# Access Compliance Report

## Public Rights-of-Way

Intersection ID: N/A	Main Street: E_TRADE_ST	Cross Street: S_COLLEGE_ST	Location: NW
ADA ID: DD48E823EEAE	Ramp Type: Perp	Initial Pass/Fail: Fail	Overall Compliance: No
		Severity Score: 12.5

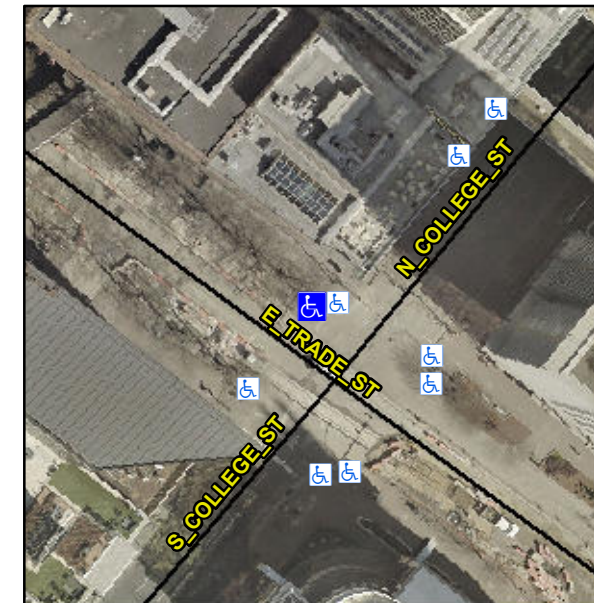
Compliance	Description	Data	Compliance	Description	Data
N/A	Ramp Length (in)	69.0	Yes	Ramp Slope (%)	5.7
Yes	Ramp Width (in)	48.0	No	Ramp XSlope (%)	6.9
N/A	Flare Type LT	N/A	N/A	Flare Type RT	N/A
N/A	Flare Slope LT (%)	N/A	N/A	Flare Slope RT (%)	N/A
N/A	Flare Traversable LT?	N/A	N/A	Flare Traversable RT?	N/A
N/A	Landing Length (in)	N/A	N/A	DWS Provided?	N/A
N/A	Landing Width (in)	N/A	N/A	DWS Contrast?	N/A
N/A	Landing Slope (%)	N/A	N/A	DWS Length (in)	N/A
N/A	Landing X Slope (%)	N/A	N/A	DWS Full Width?	N/A
N/A	Landing Curb? (Y/N)	N/A	N/A	DWS Offset (in)	N/A
N/A	Shared Landing?	N/A			
N/A	Gutter Ponding?	N/A	N/A	Gutter Slope (%)	N/A
N/A	Gutter Lip Ht (in)	N/A	N/A	Gutter X Slope (%)	N/A
N/A	Painted X Walk1?	Yes	N/A	Painted X Walk2?	N/A
	X Walk 1 Direction	To SW		X Walk 2 Direction	N/A
N/A	X Walk 1 Width (in)	123.0	N/A	X Walk 2 Width (in)	N/A
	X Walk 1 Slope (%)	4.2		X Walk 2 Slope (%)	N/A
	X Walk 1 X Slope (%)	3.0		X Walk 2 X Slope (%)	N/A

**Remove & Replace Entire Ramp.**

**R304.5.3**
